RIDER 850=8/12

REPAIR KIT FOR STEERING SPINDLE REF. NO. 506 87 68-01

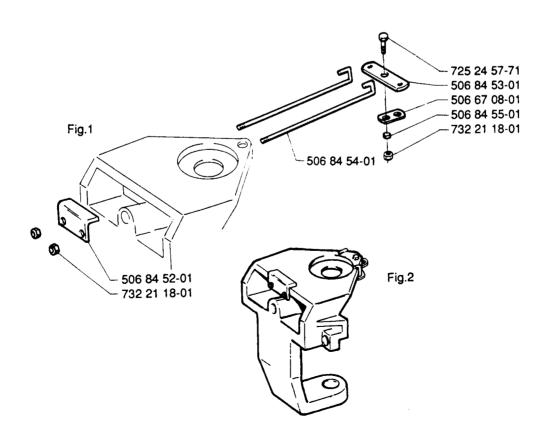
On some Rider 850 with casted steering spindle, the screw (Ref. No. 725 24 53-51), which holds the steering return spring, has worn out the hole in the steering spindle. The screw finally comes loose from the steering spindle. In order to avoid changing the whole steering spindle, which requires approx. 8 hours work, we have introduced a repair kit.

Included parts are shown in ill. 1.

The repair kit is mounted without removing any other parts on the machine. The plate (Ref. No. 506 84 53-01) replaces the worn out hole in the steering spindle. Thread the draw bars through the outer hole in the plate. Place the draw bars under the upper plane on the steering spindle, facing backwards. Mount the bracket (Ref. No. 506 84 52-01) on the draw bars against the back on the steering spindle. Tighten the nuts on the draw bars. Mount the screw (Ref. No. 725 24 57-71), link (Ref. No. 506 67 08-01) and bushing (Ref. No. 506 84 55-01) in the central hole on the plate (Ref. No. 506 84 53-01). The bushing should be mounted in the hole in the link. Tighten up the nut hard, (Ref. No. 732 21 18-01). See illustration 2, fully assembled repair kit. Mount the steering return spring.
